ALLIANCE CONSULTING ENGINEERS, INC.

To: All Bidders and Plan Holders Project No. 13176-0032
Re: Addendum No. 3 Provided: E-Mail
Project: Phase II Infrastructure Improvements at the Chapin Business and
Technology Park in Lexington County, South Carolina
Date: Wednesday, January 7, 2015
Bid Date: Monday, January 12, 2015 at 2:00 P.M.
Bid No.: B15029-01/12/15S Page 1 of 64

A. Clarifications to Contract Documents and Specifications:

TOP PLAN
 SCALE: 1/4" = 1'-0"
PARTIAL VIEW

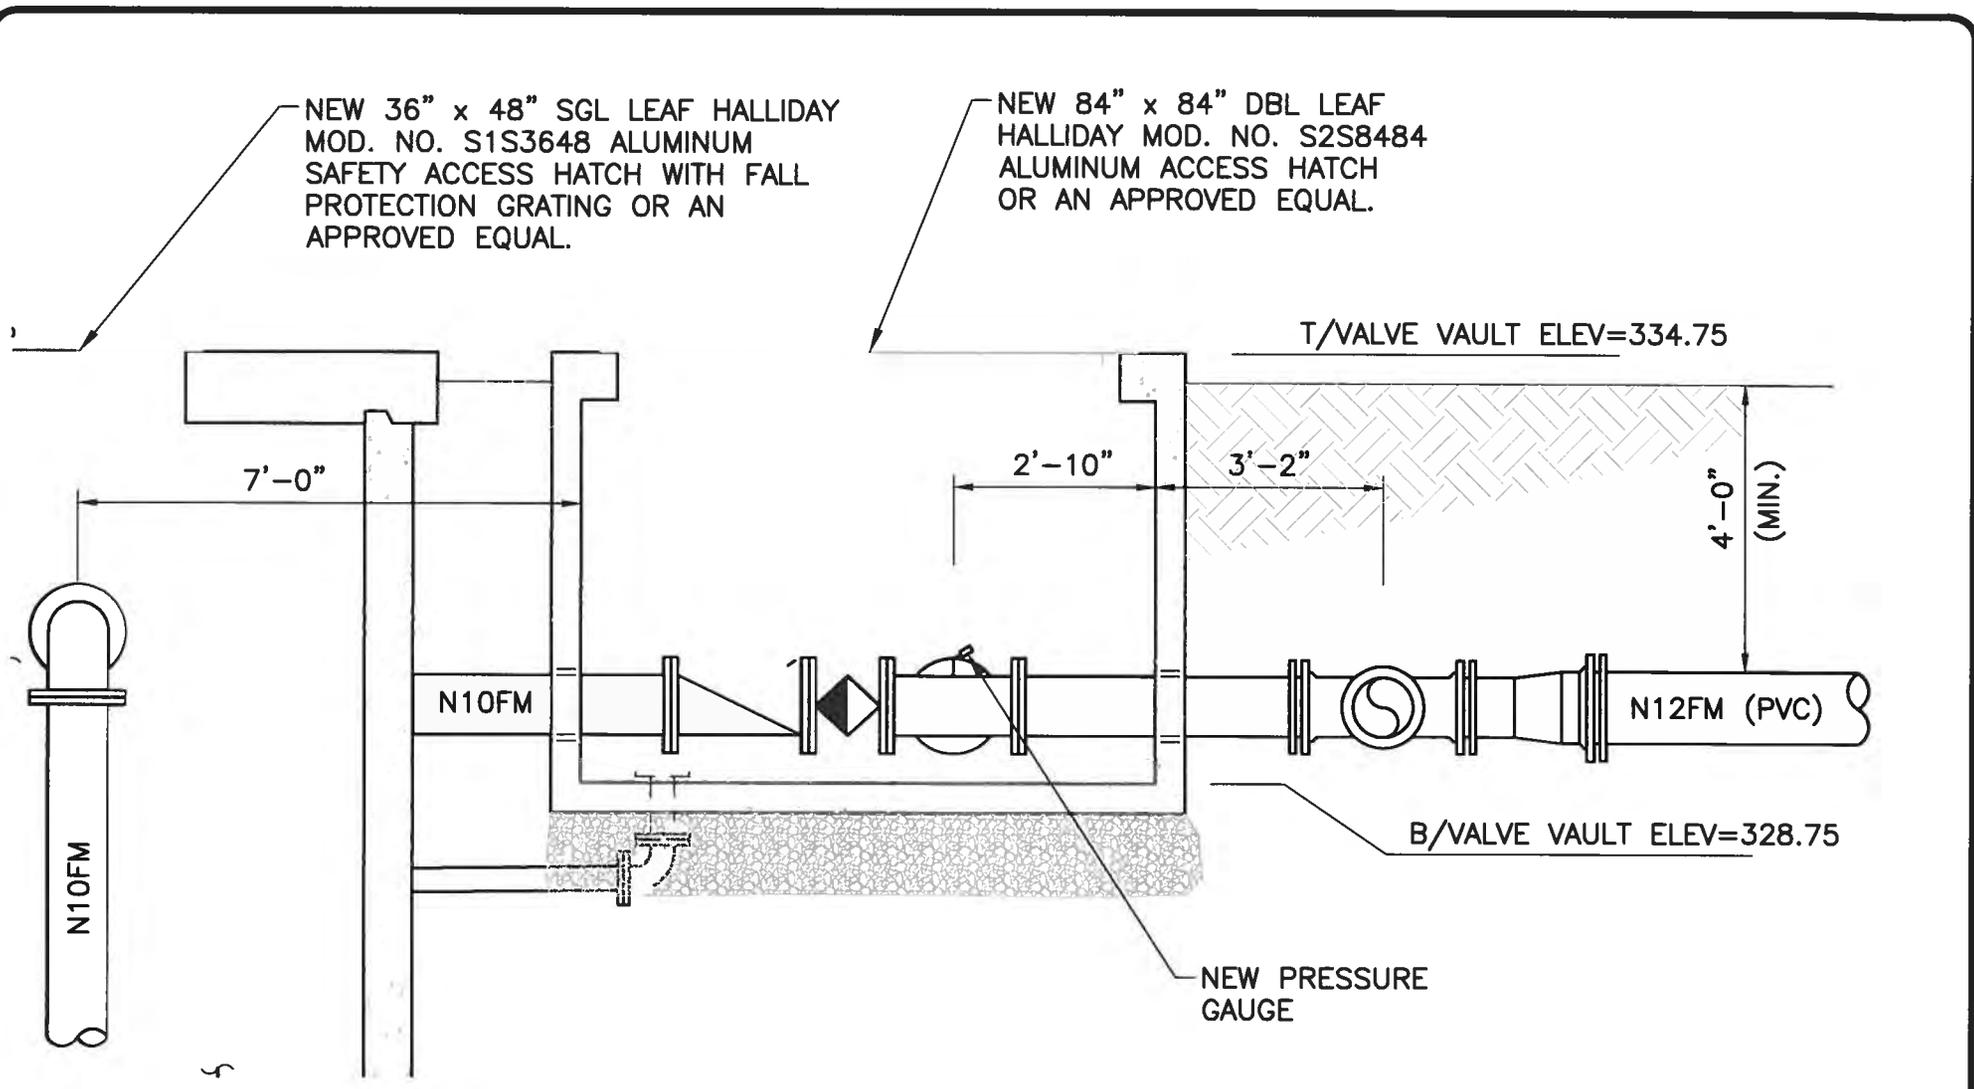
4. **Alliance Consulting Engineers, Inc. Specification Section 02930 – Landscape Work:** Revise Section 02930 with Section 02930 Revised January 2015.
5. **Drawing Sheet 4 of 13 – Chapin Business and Technology Park Wastewater Collection System – Pump Station:** (A) Replace detail titled “Top Plan” revised January 2015.

- a. **The hatch for the valve vault to be utilized will be a new 84” x 84” Double Leaf Halliday Model No. S2S 8484 Aluminum Access Hatch or approved equal. Chapin Business and Technology Park Wastewater Collection System – Pump Station drawings prepared by American Engineering Consultants, Job No. 13-015, Sheet 4 of 13 has been revised and enclosed.**

SECTION C
TYP
 SCALE: 3/8" = 1'-0"

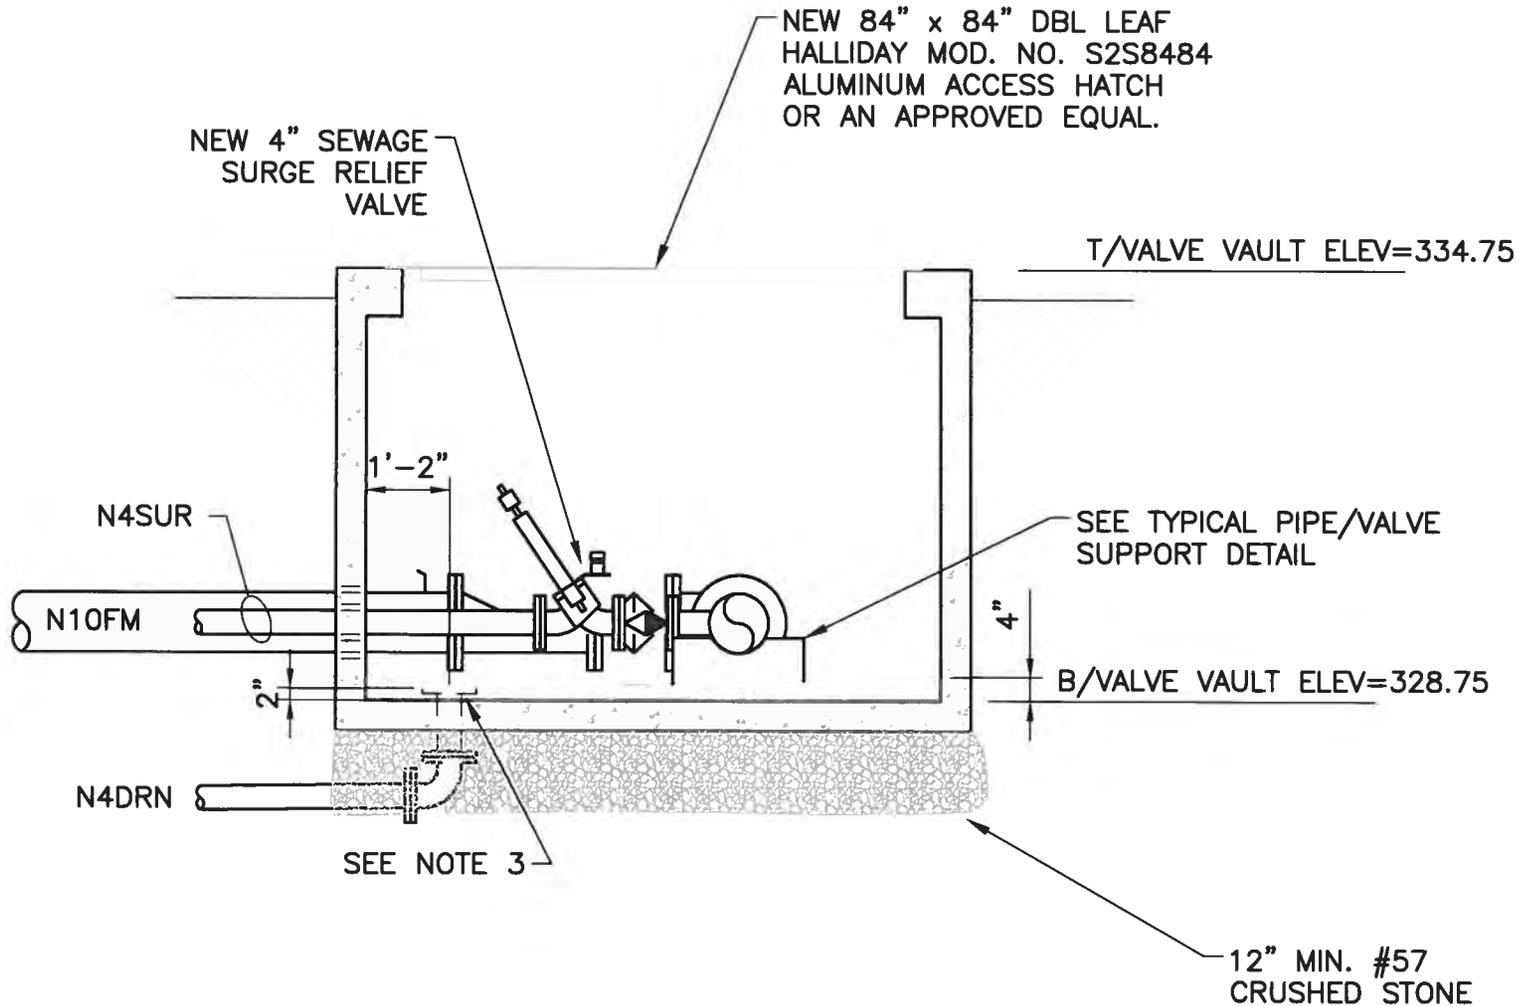
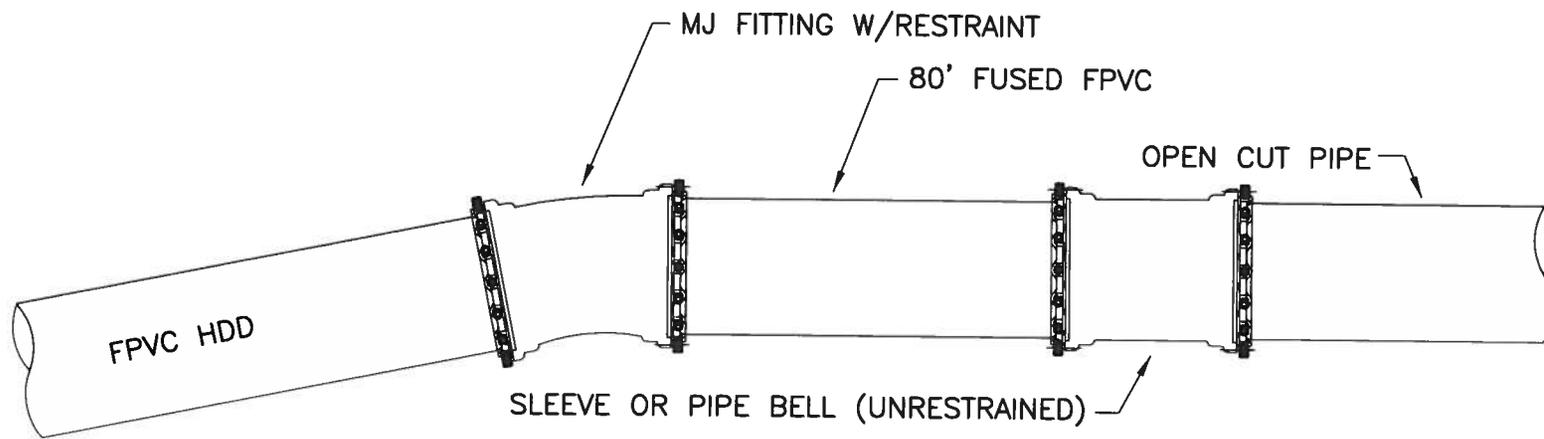
6. **Drawing Sheet 6 of 13 – Chapin Business and Technology Park Wastewater Collection System – Pump Station:** (A) Replace detail titled “Section A”. (B) Replace detail titled “Section B”. (C) Replace detail title “Section C” revised January 2015.

TYPICAL FPVC CONNECTION DETAIL
NOT TO SCALE

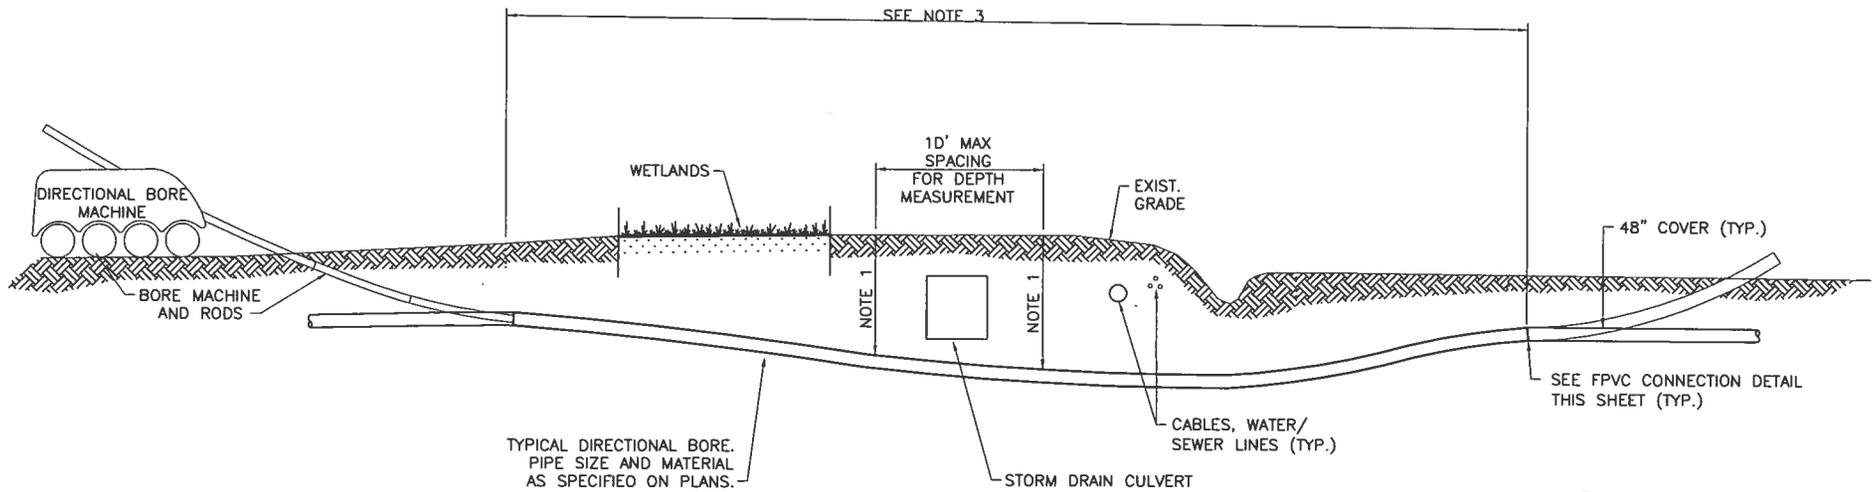
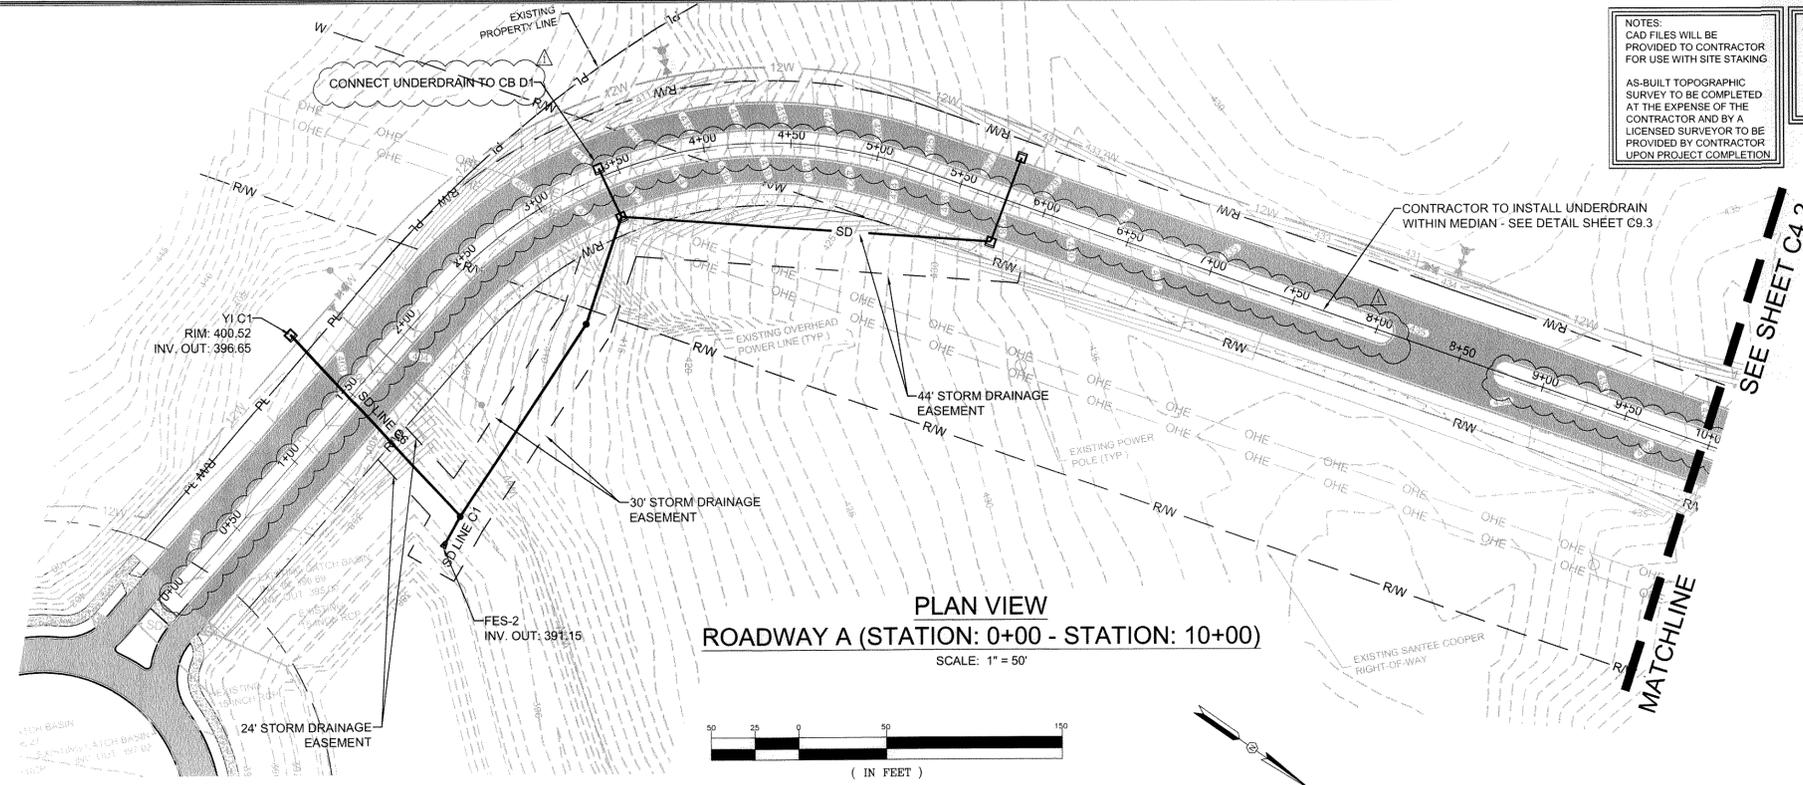
7. **Drawing Sheet 17 of 18 – Chapin Business and Technology Park Wastewater Collection System – 12” Force Main:** (A) Add detail titled “Typical FPVC Connection Detail”. (B) Replace detail titled “Typical Directional Bore Detail” with revised “Typical Directional Bore Detail” revised January 2015.

FILE NAME: C42.DWG SHEET C4.2 OF 73
 SURVEY.DWG PROJECT NO. 13176-0032
 DWG NO. 01.782-D14

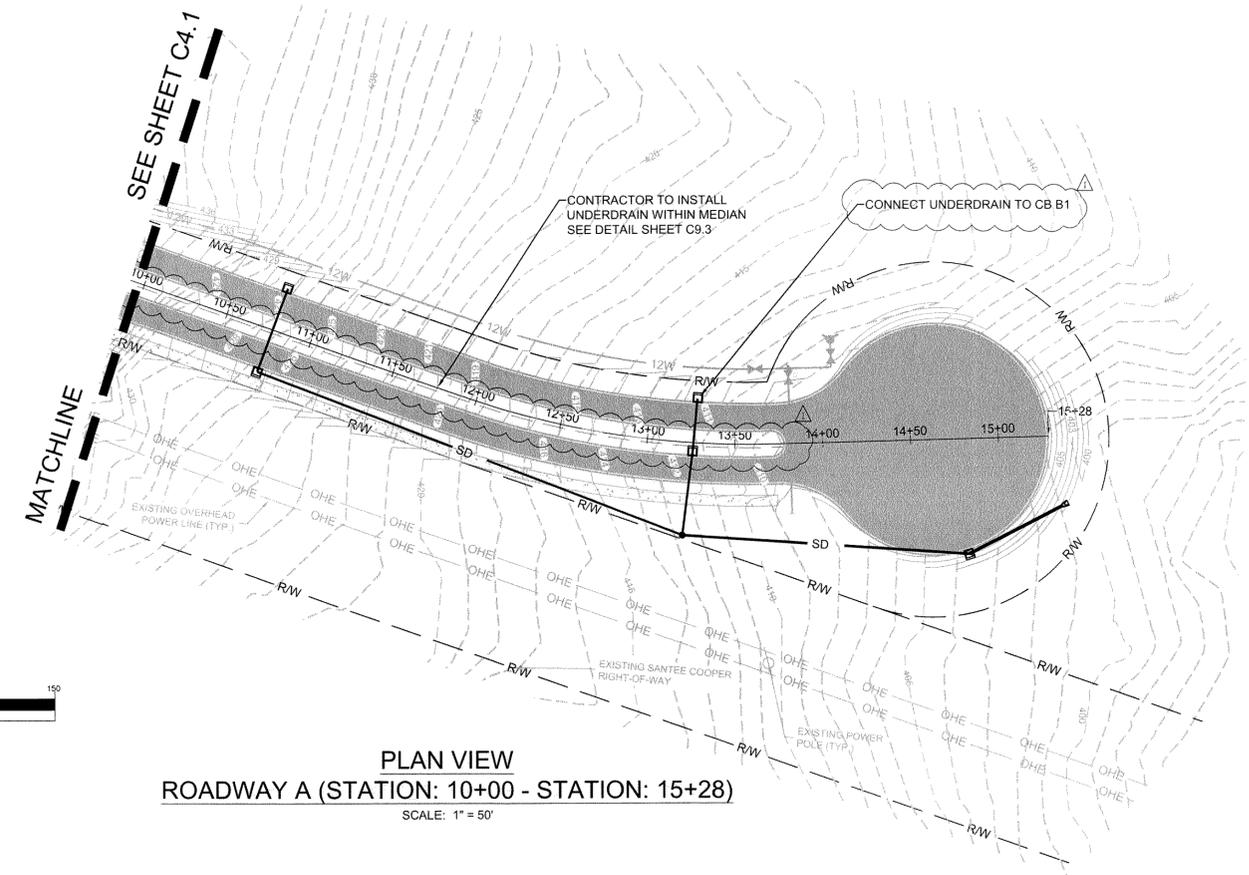
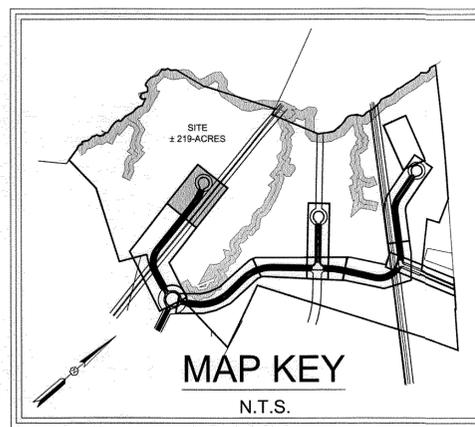
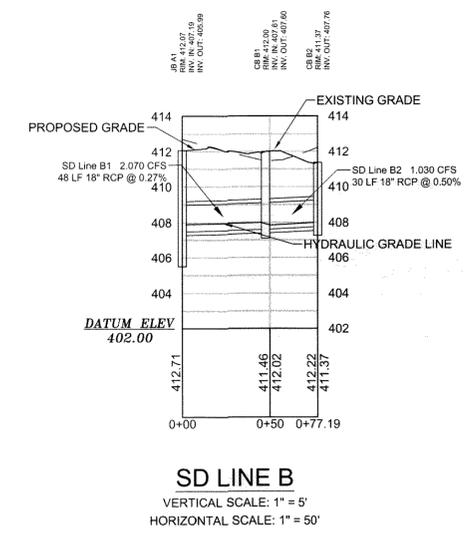
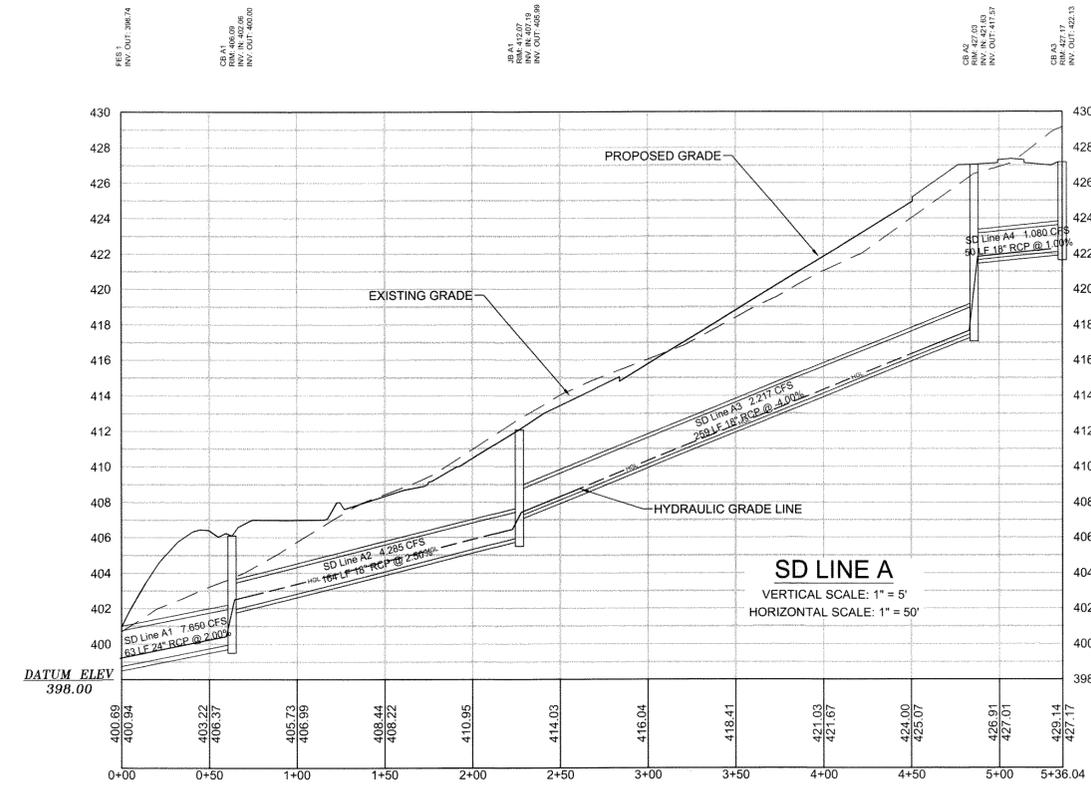
27. *Please provide connection locations for 10” median drain on storm drainage plans.*
- a. **Refer to Alliance Consulting Engineers, Inc. drawings (Dwg. No. 01,782-D14, dated September 2013) Sheets C4.1 through C4.8 revised January 6, 2015 for underdrain information. Sheets C4.1 through C4.8 have been enclosed.**

29. *On Alliance Consulting Engineers, Inc. drawings (Dwg. No. 01,782-D14, dated September 2013), Sheets E3.1 through E3.4 it appears that lights are centered in median if so this will conflict with 10" median under drain. Please provide clarification.*

- a. Lights are required to be centered. Alliance Consulting Engineers, Inc. drawings (Dwg. No. 01,782-D14, dated September 2013) Sheets C4.1 through C4.8 revised January 6, 2015 indicate the location of the median under drain, which is offset from the center of the median to avoid a conflict with lighting. Sheets C4.1 through C4.8 have been enclosed.**

REVISION	DATE
ADD UNDERDRAIN CONNECTION	JANUARY 06, 2015
